PROJECT No.1 Dawlish Road, Chorlton, M21 8XR			
CLIENT Sarah & Dave Rigby			
DWG. NO. 377_ PL006	Proposed Ground & First Floor Plans	REVISION A	DRAWN BY STS
DATE November 2022		ISSUE Planning Issue	SCALE 1:50@A3

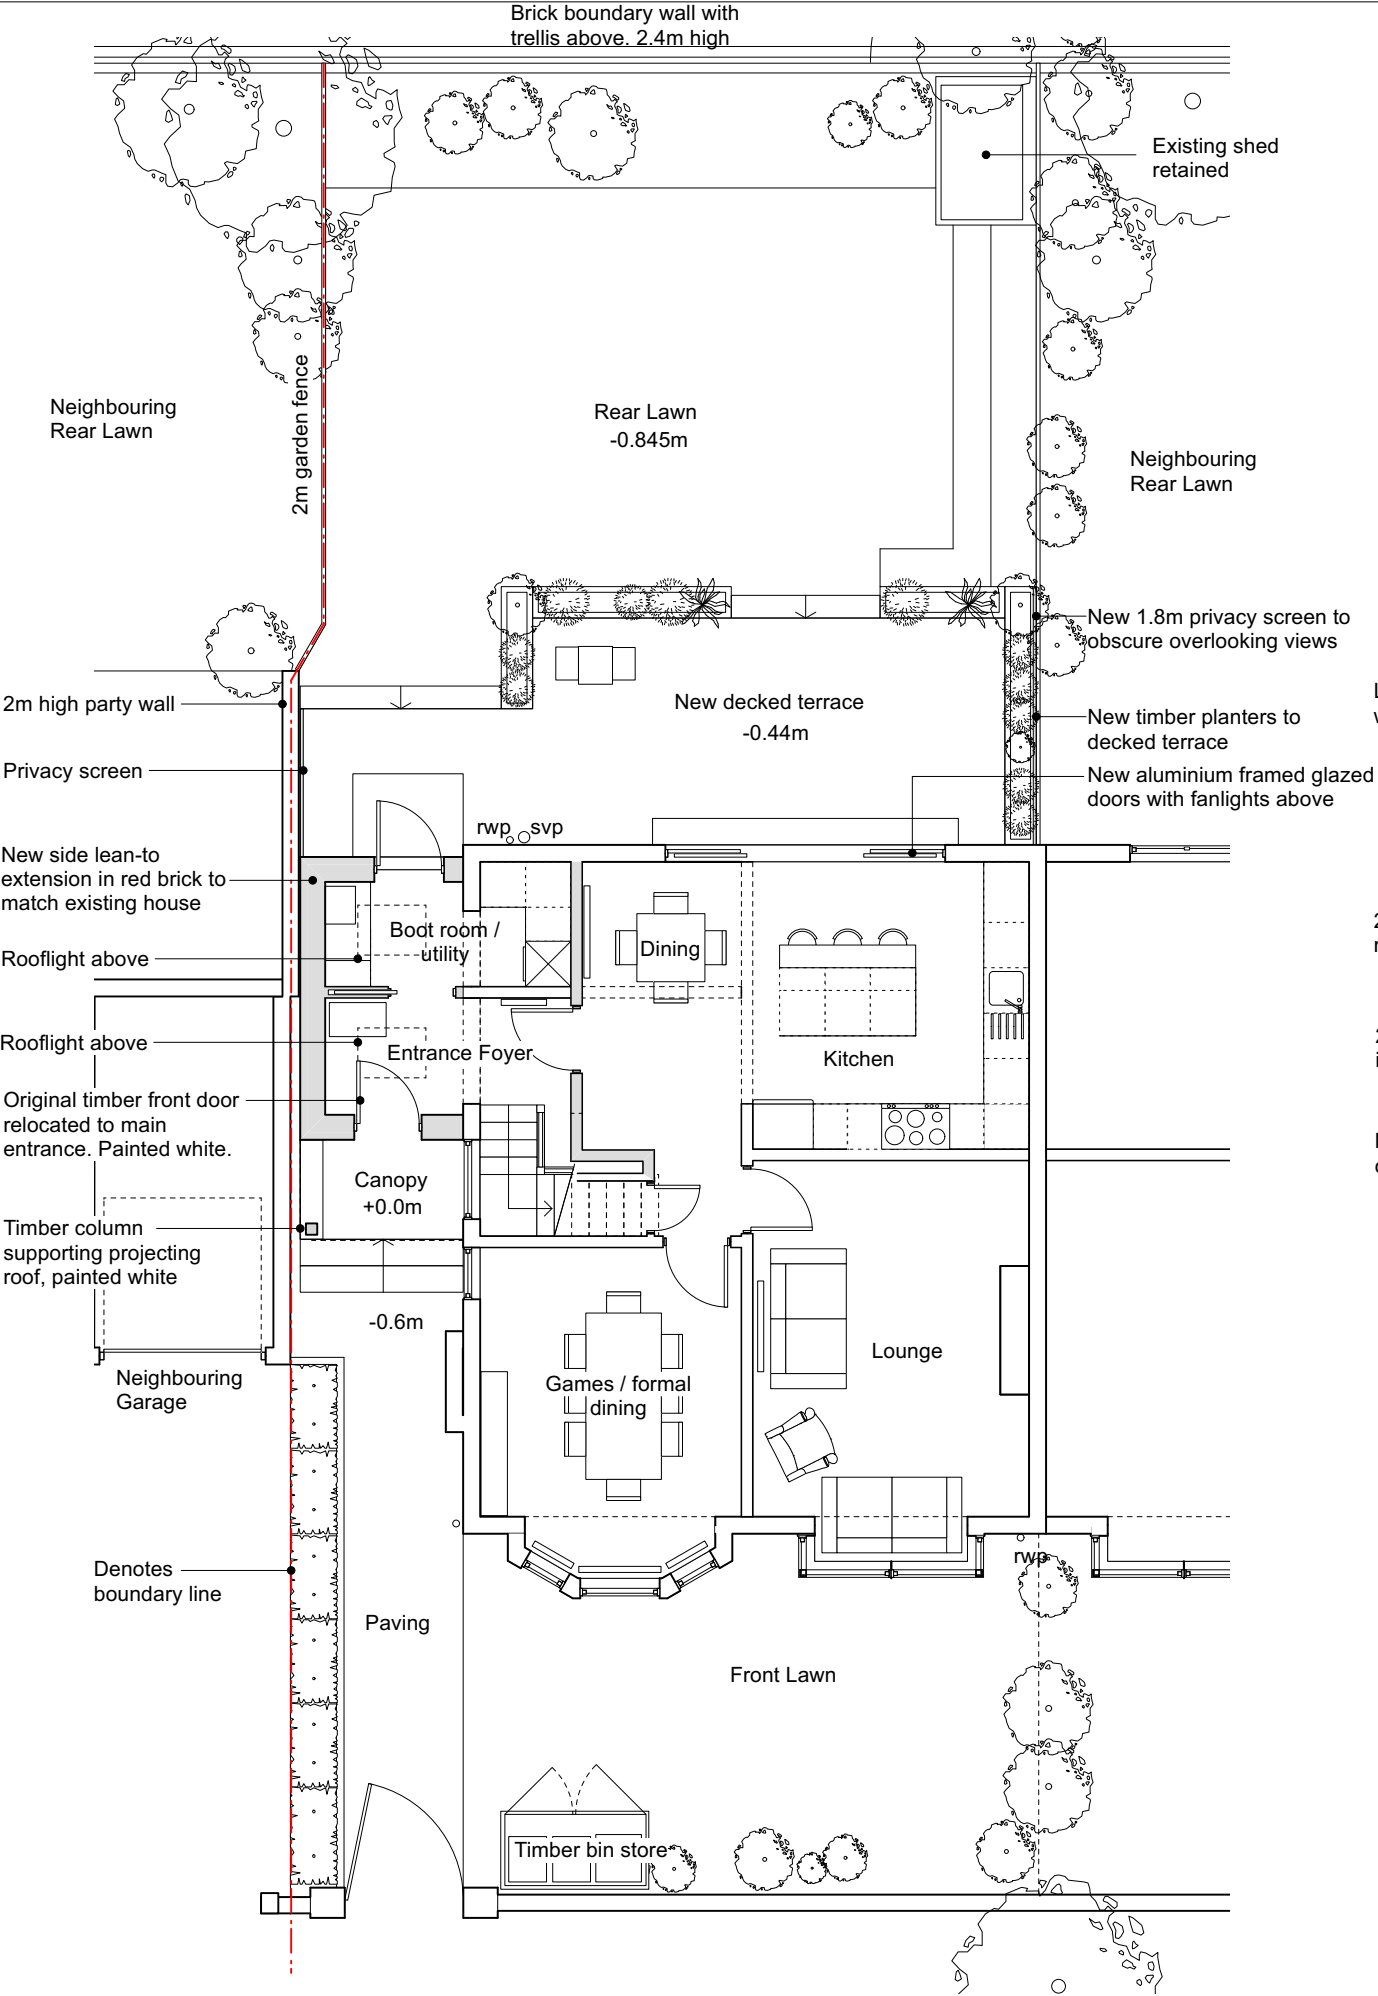
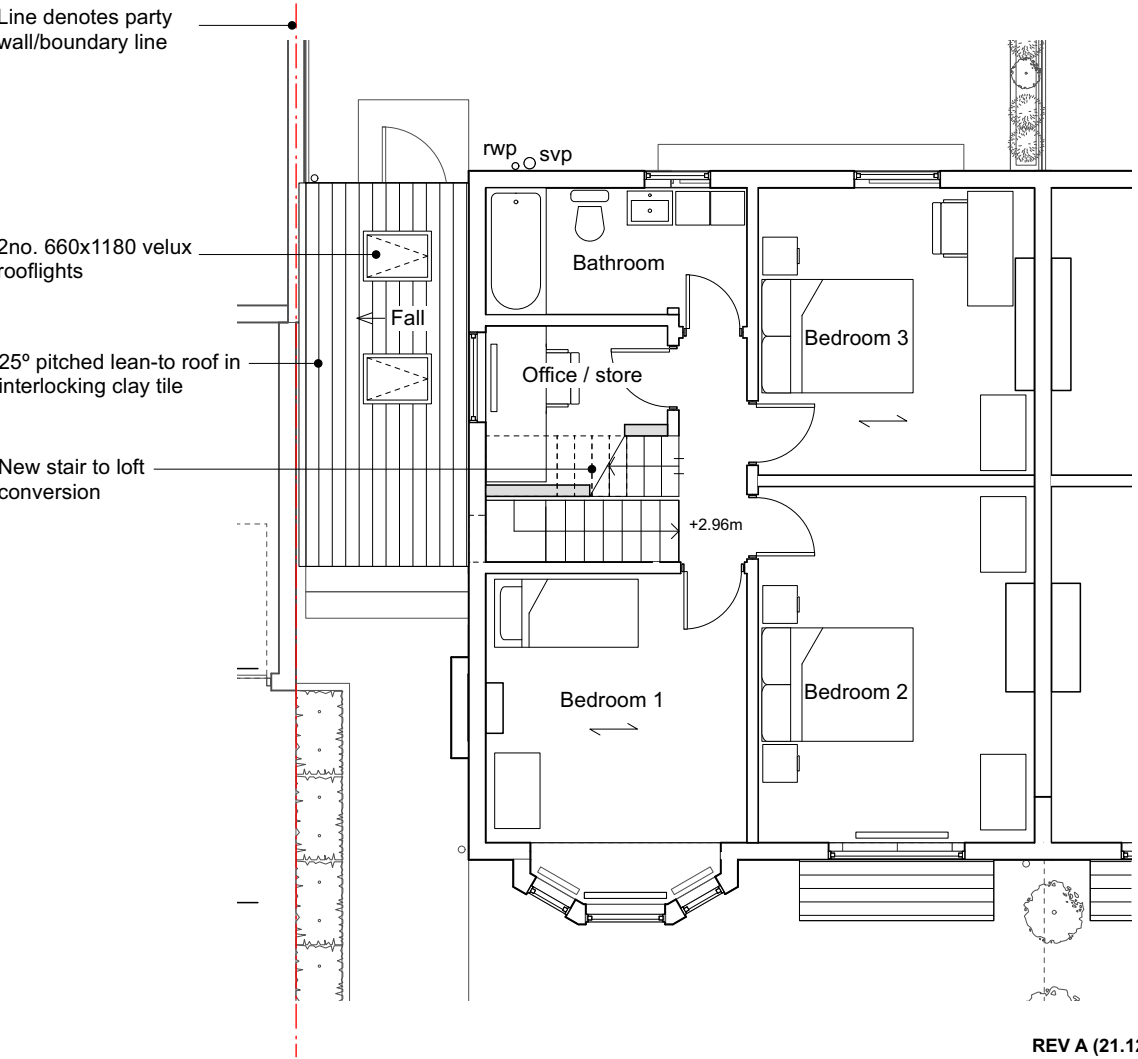
REV A (21.12.22) Revised to show privacy screens to rear deck in line with planning officer comment. (STS)
